UNITED STATES PATENT AND TRADEMARK OFFICE

APPLICATION NO.	FILING DATE	FIRST NAMED INVENTOR	ATTORNEY DOCKET NO.	CONFIRMATION NO.
10/618,821	07/15/2003	Rodney Craig MacAulay	0641-0250P	5924
2292	7590	04/06/2005	EXAMINER	
BIRCH STEWART KOLASCH & BIRCH			LUONG, VINH	
PO BOX 747			ART UNIT	PAPER NUMBER
FALLS CHURCH, VA 22040-0747			3682

Office Action Summary	Application No.	Applicant(s)
	10/618,821	MACAULAY ET AL.
	Examiner	Art Unit
	Vinh T Luong	3682

ATTACHMENT

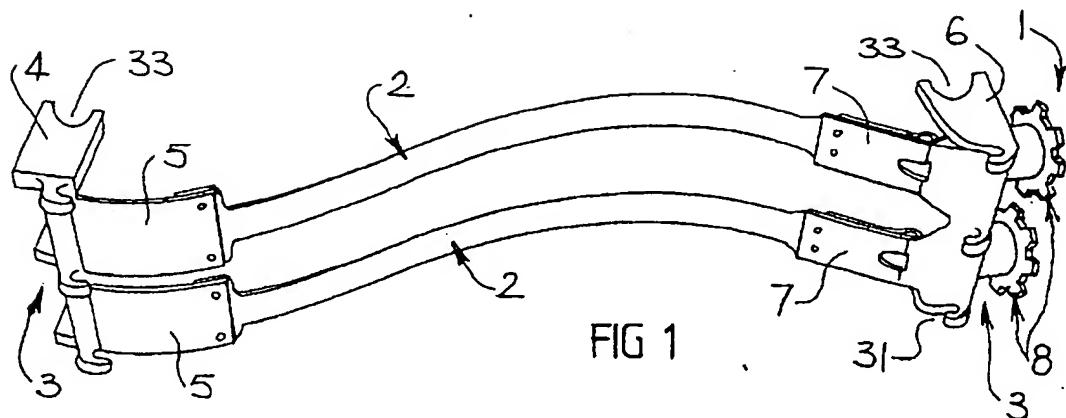
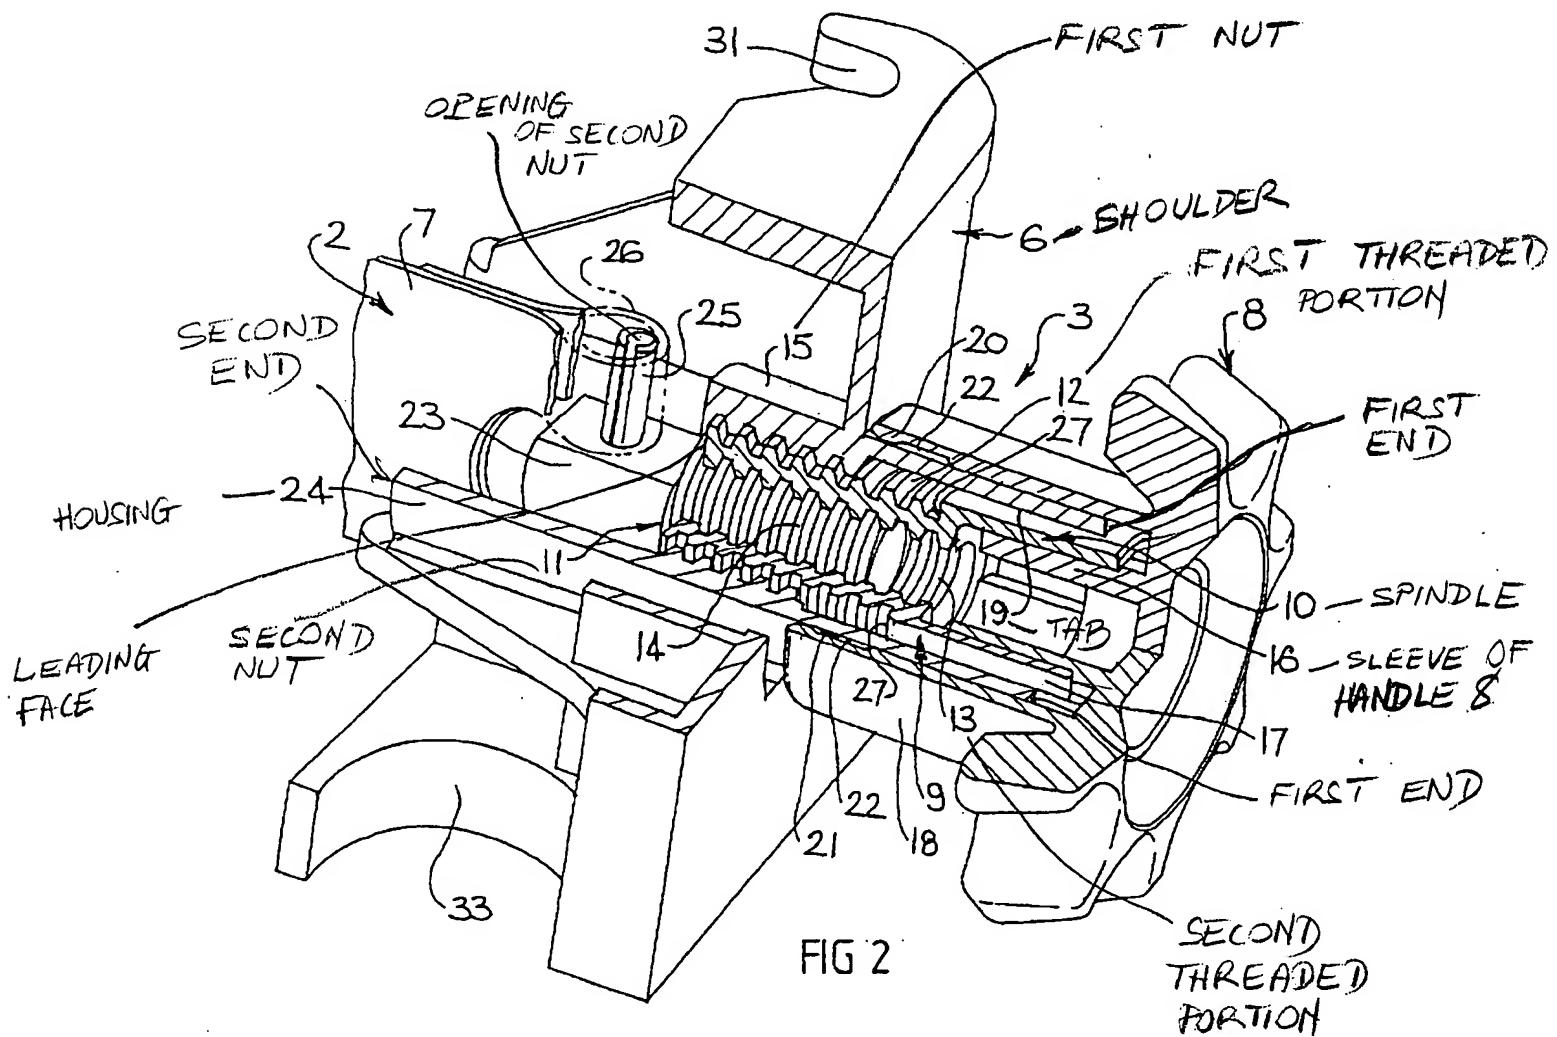
a housing 24 having a longitudinal passage extending between a first end (see

Attachment) and a second end (Att.) of the housing 24 and defining an opening at or adjacent to the second end;

Regarding claim 11, the first nut 15 is held against movement longitudinally of the housing 24 by being located between a shoulder 6 and at least one tab 19, and wherein the shoulder 6 is defined by the housing 24 and faces towards the first end (Att.) and the at least one tab 19 is formed integrally with the housing 24 and protruding resiliently into the passage.

Regarding claim 19, said abutment means 27 is provided by a lateral tab 17 projecting from the spindle 10, with the tab 17 having a leading face (Att.) in the direction of rotation of the spindle 10 for movement towards the second end, and the abutment means 27 is adapted to stop rotation of the spindle 10 by said abutment face 27 abutting a surface defined by the housing 24. Id., col. 4, line 64 through col. 5, line 3.
